AL HILLAH POLICE FIRING RANGE
AL HILLAH, IRAQ

SIGIR PA-06-076
JANUARY 08, 2007

SUBJECT: Report on Project Assessment of the Al Hillah Police Firing Range,
Al Hillah, Iraq (Report Number SIGIR-PA-06-076)

Site Photo 7. Target enclosure entrance

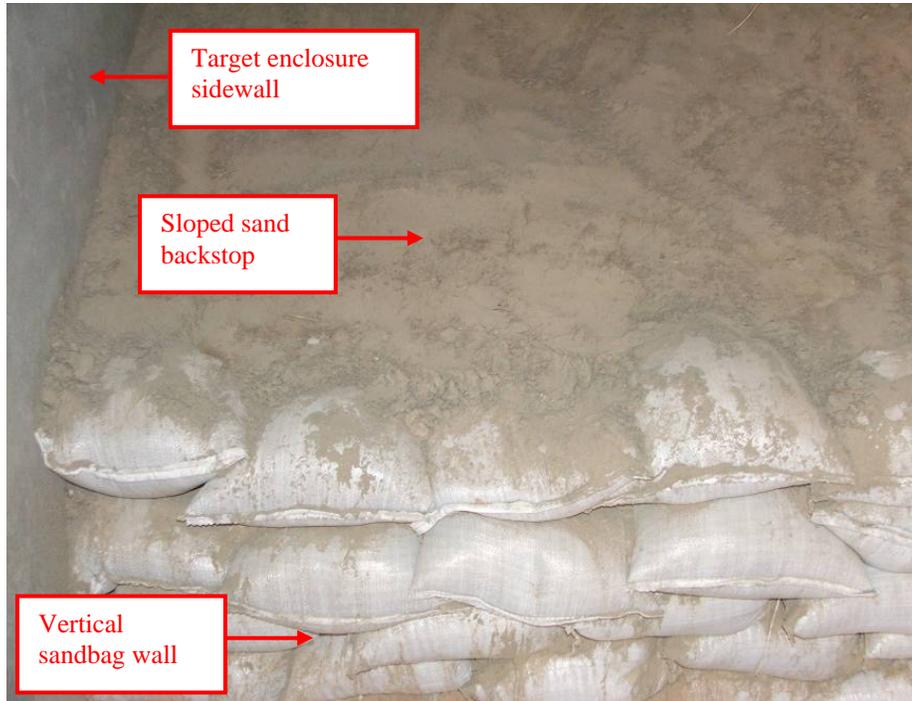
The design for the rifle firing tubes shown in Site Photos 6, 7, and 8 called for a reinforced concrete tube, 25 m in length. The target was housed in an enclosure constructed with grout filled masonry sidewalls and a reinforced concrete back wall and cover. The 2 m wide by 2.1 m high firing tube was designed with reinforced concrete side walls, floor, and cover, each 10 centimeters (cm) thick.

Site Photo 11. Generator, electrical panel, and automatic transfer switch (ATS)

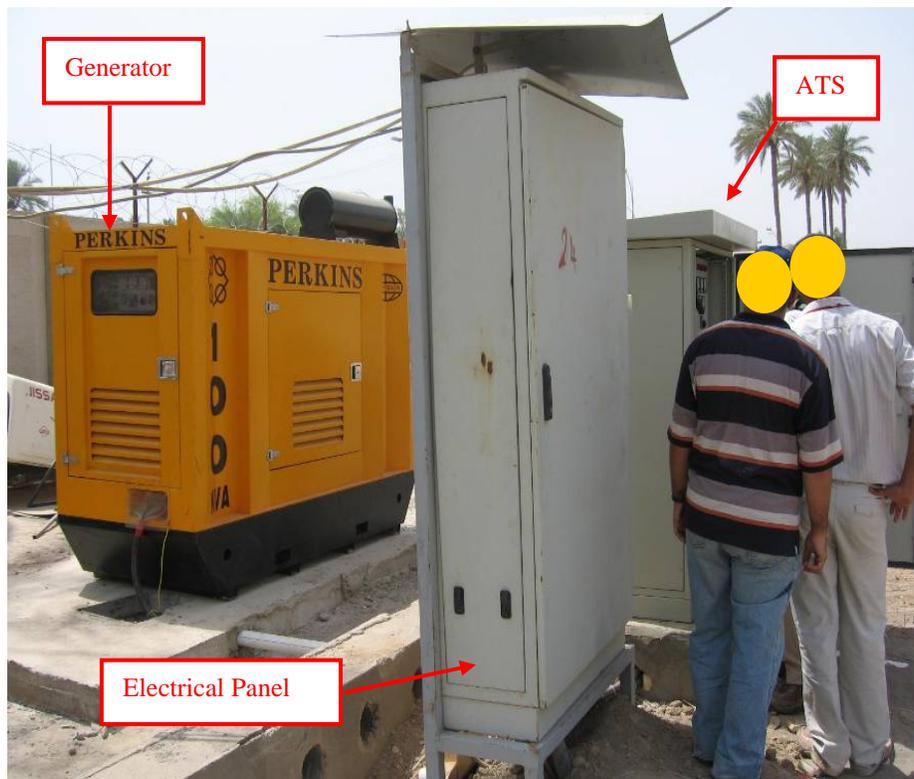
Site Photo 11 shows the 100 kVA generator installed on the concrete slab, the electrical panel, and the automatic transfer switch (ATS). The generator cover and the external fuel tank were not yet installed.

On the rear side of the electrical panel shown in Site Photo 12, we found some portions of the metal frame rusted. Additionally, the cable connecting the ATS to the panel was not enclosed in rigid conduit.
